W. HOLLINGSHEAD
102.5' x 102.5' x 102.5'
L.C.D.R.
P.D. NO. 1A-59-01

SEPTIC SYSTEM SITE PLAN FOR
SAL. HOLLINGSHEAD

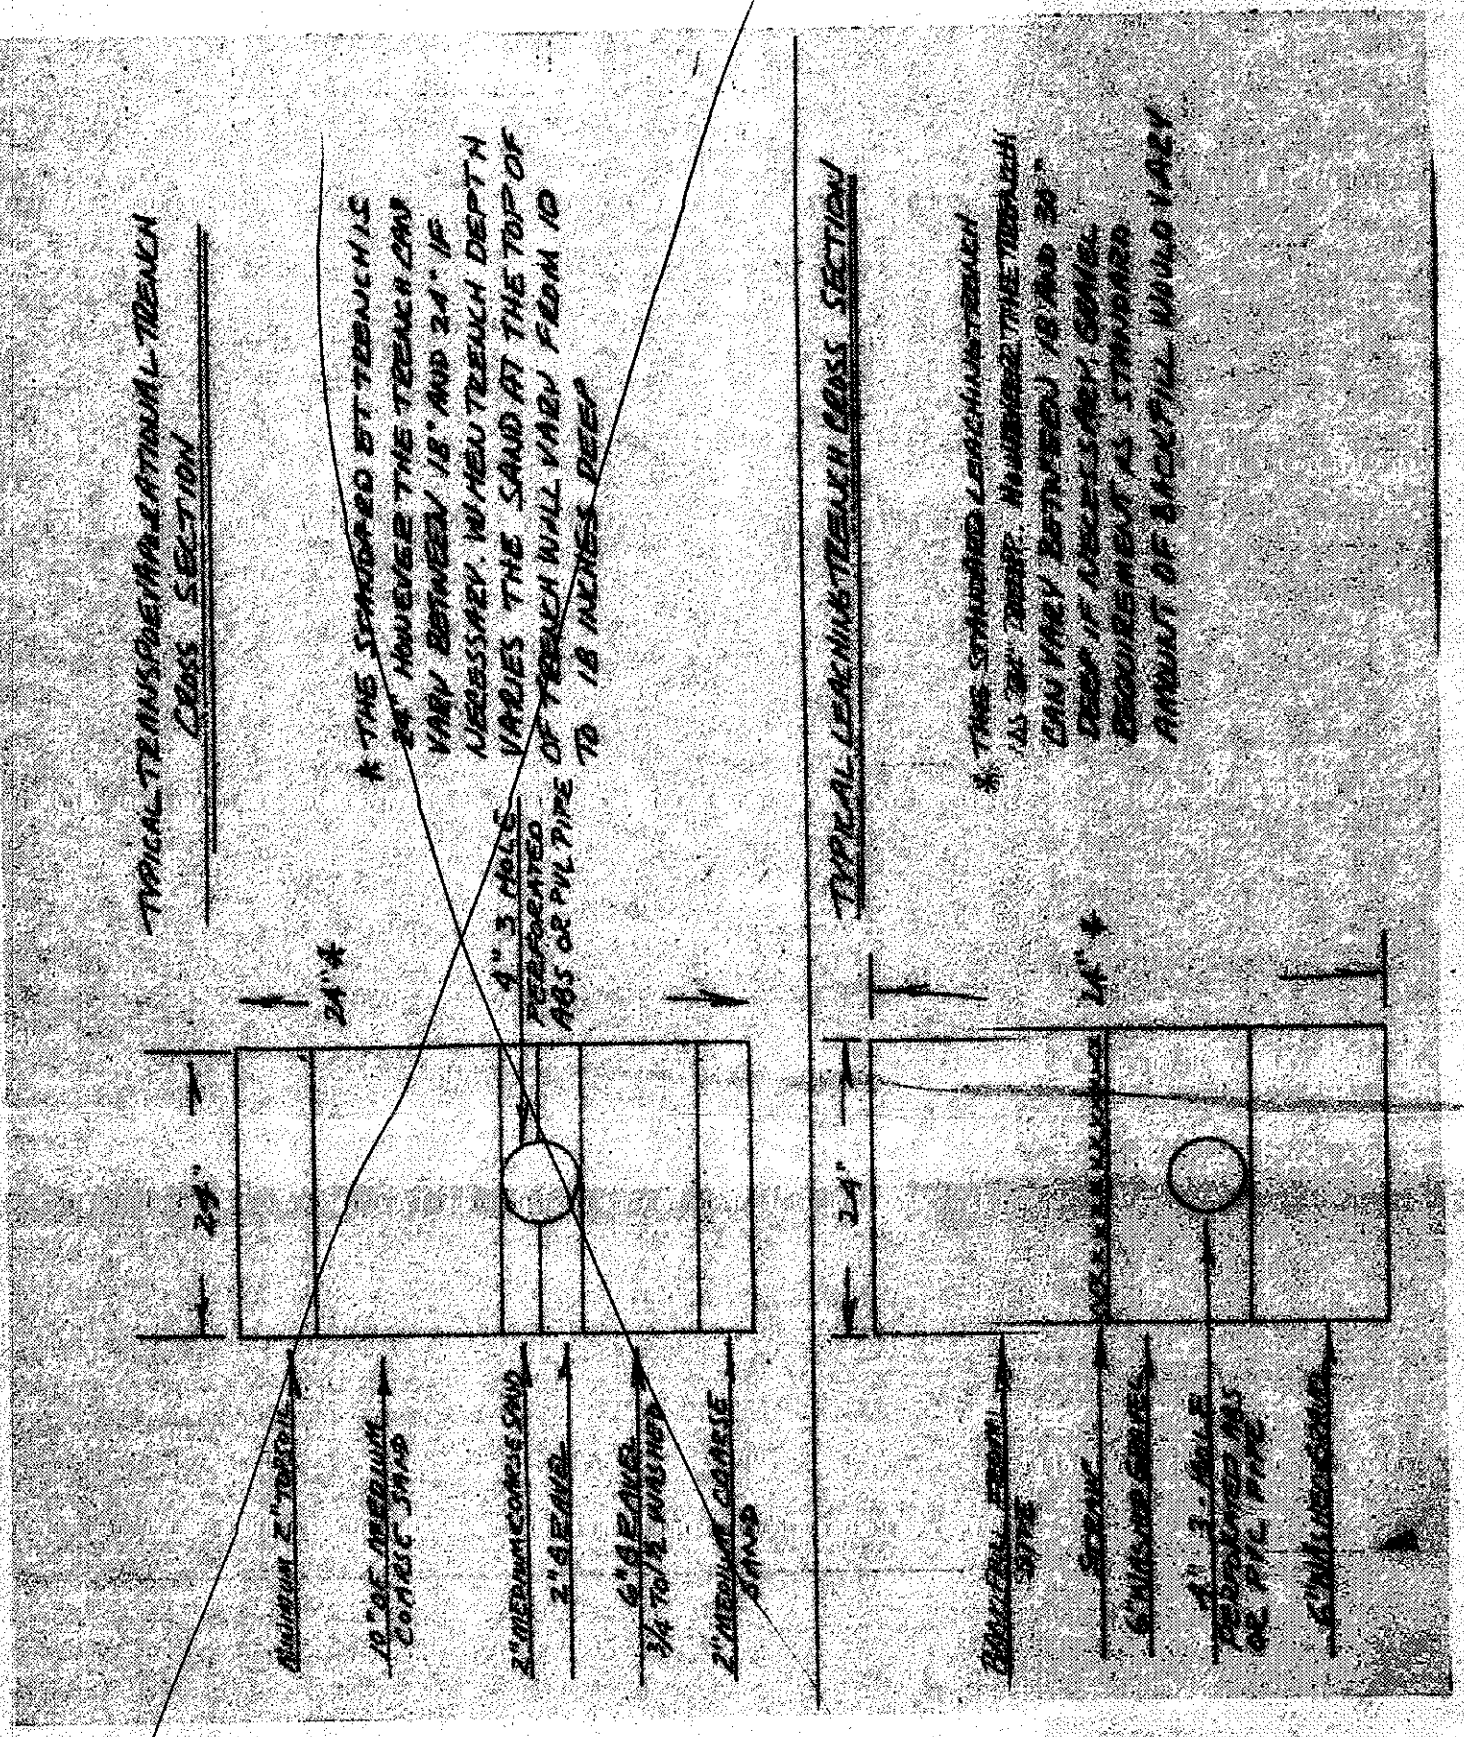
LOW YIELD WATER
FIXTURES REQUIRED
ON ALL
Showers
Toilets

SEWAGE DISPOSAL PRINT MUST BE OBTAINED BY A LAKE COUNTY LICENSED INSTALLER BEFORE INSTALLATION IS STARTED.
